MITIGATION PLAN

VILE CREEK MITIGATION SITE

Alleghany County, NC
DEQ Contract No. 5999
DMS ID No. 96582

SUBJECT: Vile Creek Mitigation Site - NCIRT Comments During 30-day Mitigation Plan Review

Plant Lists
 Planting

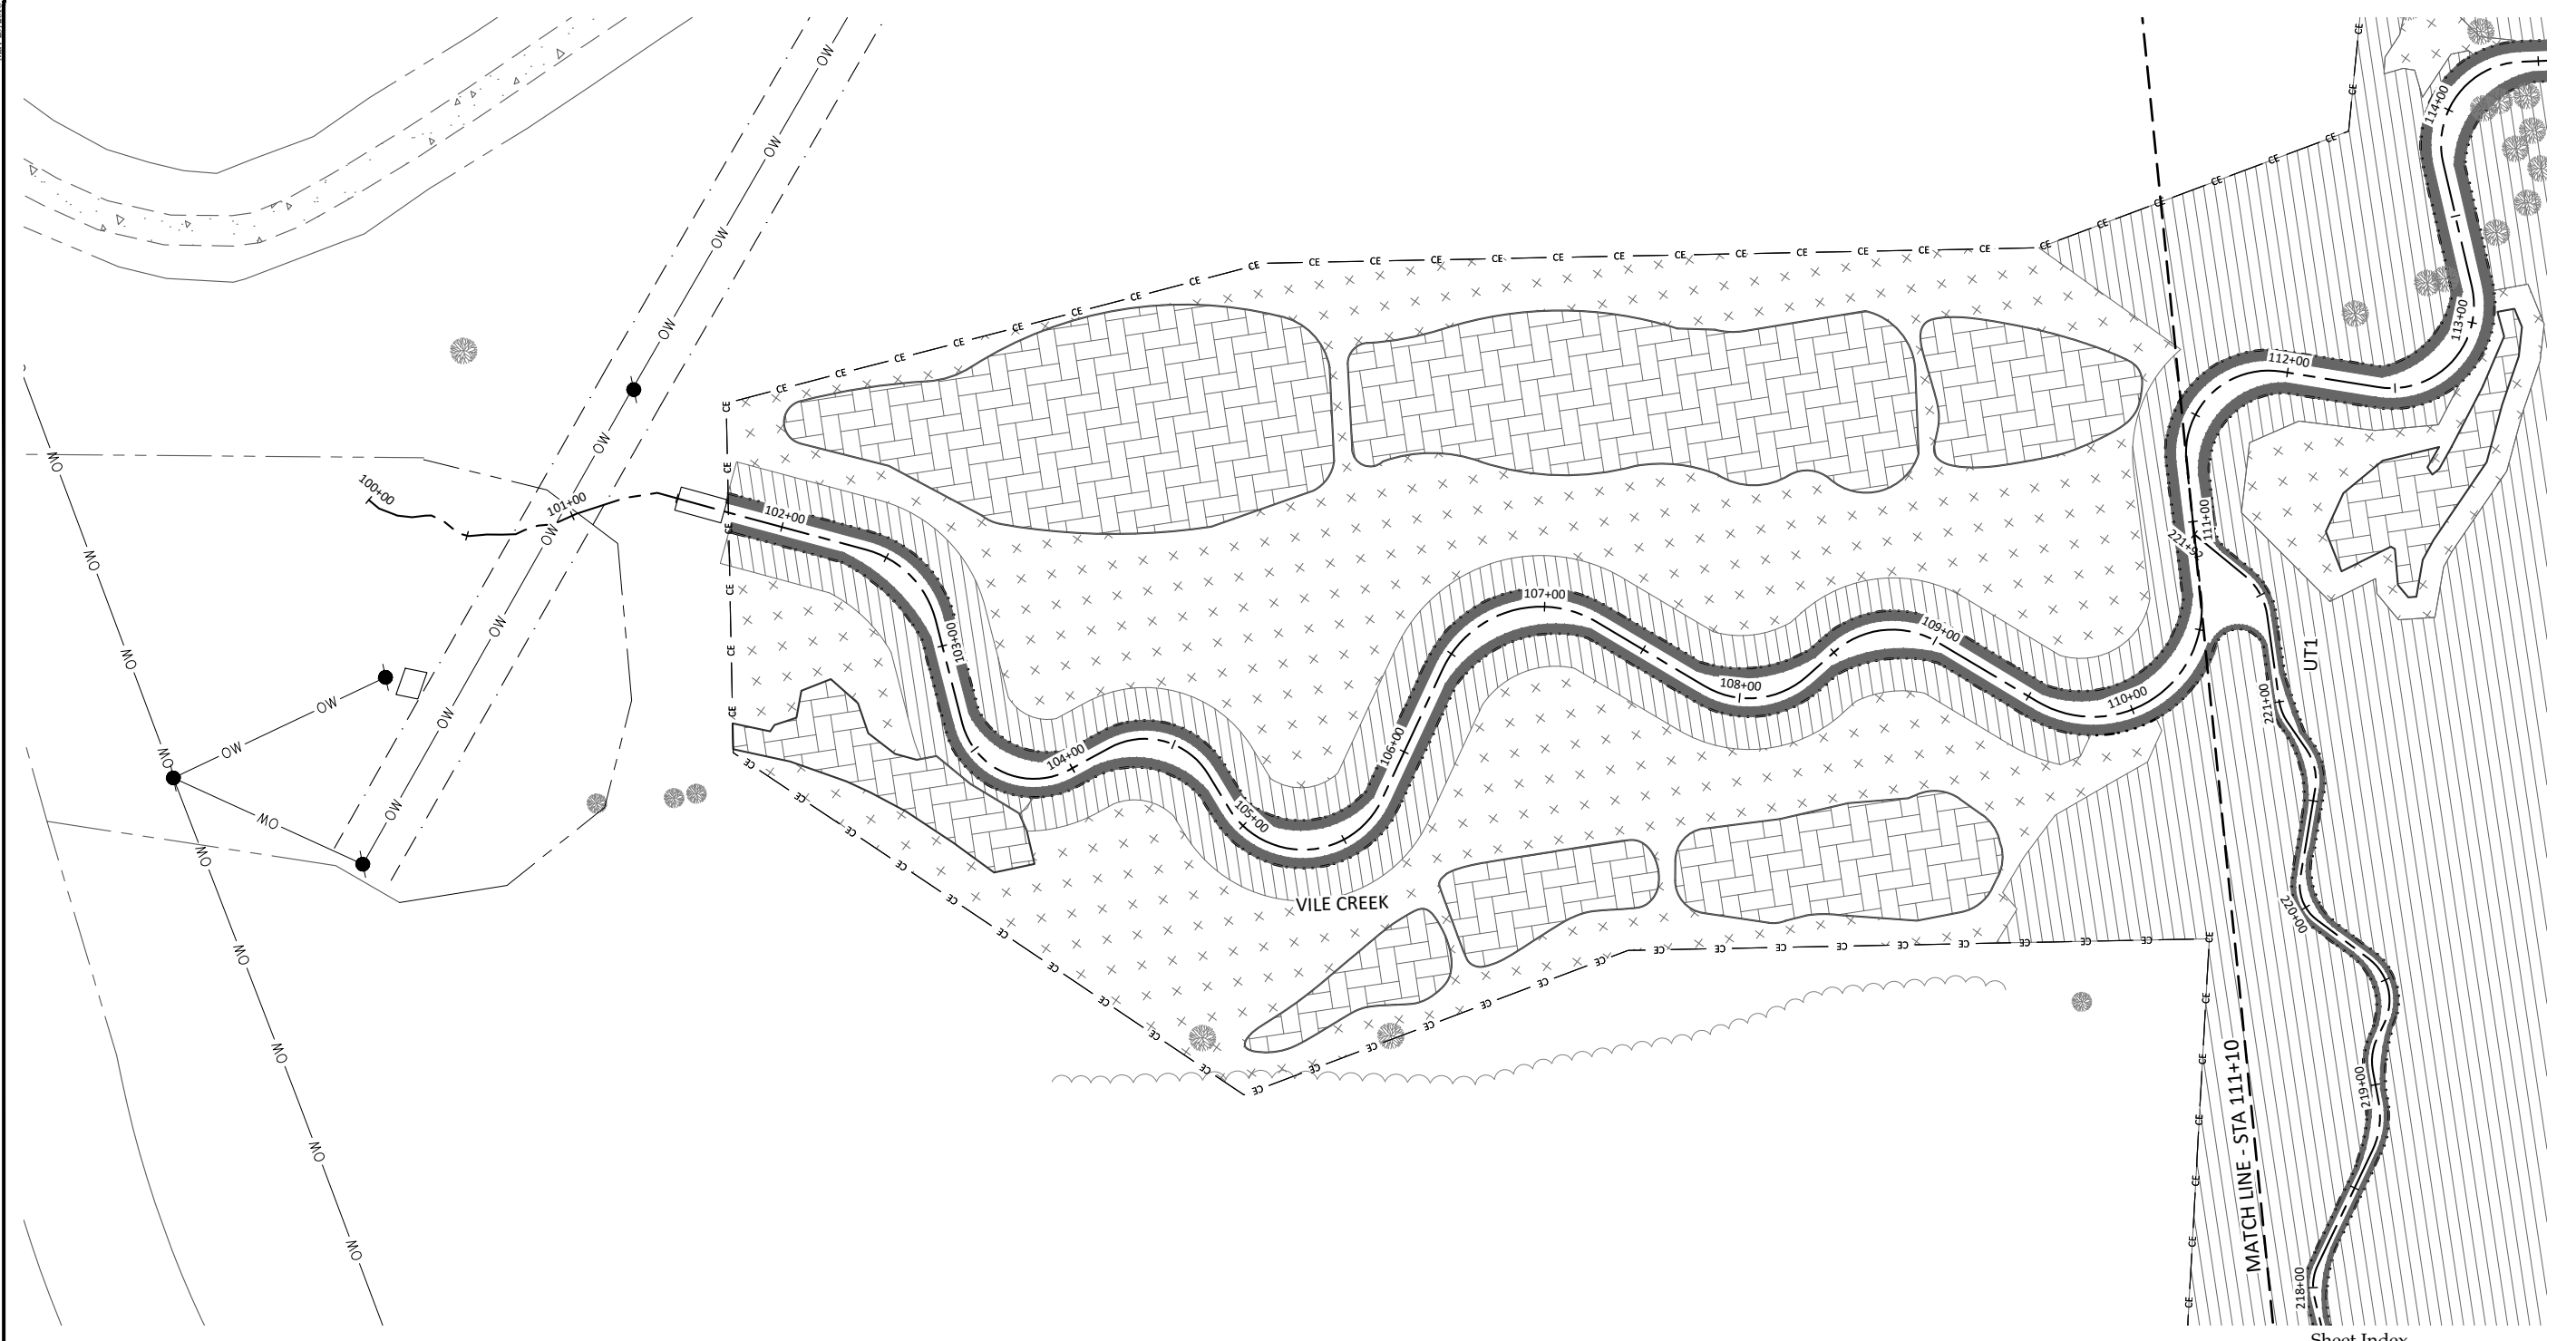
19. Sheet 4.0: The inclusion of *Acer saccharinum* (silver maple) is notable as it does not appear in Schafale and Weakley (1990) for Montane Alluvial Forest. Why was this species selected? Recommend *Betula nigra* (river birch) to replace.

20. Sheet 4.0: Recommend adding some understory species for consideration such as *Carpinus caroliniana* (ironwood) or *Lindera benzoin* (spicebush) in the planting for riparian buffers.

21. Sheet 4.0: Recommend adding *Alnus serrulata* (tag alder) live stakes in the streamside planting zone.

22. Sheet 4.0: Recommend adding *Cephalanthus occidentalis* (buttonbush) in wetland planting.

We have revised the planting plan including the removal of silver maple (pg. 46, plan sheet 4.0).

We have added buttonbush to the wetland shrub zone (pg. 46, plan sheet 4.0).

We have reduced the planting density in the wetland shrub zone. We have added native pollinators including milkweed to the seed mix which will be applied to the wetland shrub zone (pg. 47, plan sheet 4.0). In addition, we believe goldenrod and cardinal flower, among others, will volunteer on the site since they are currently well established.
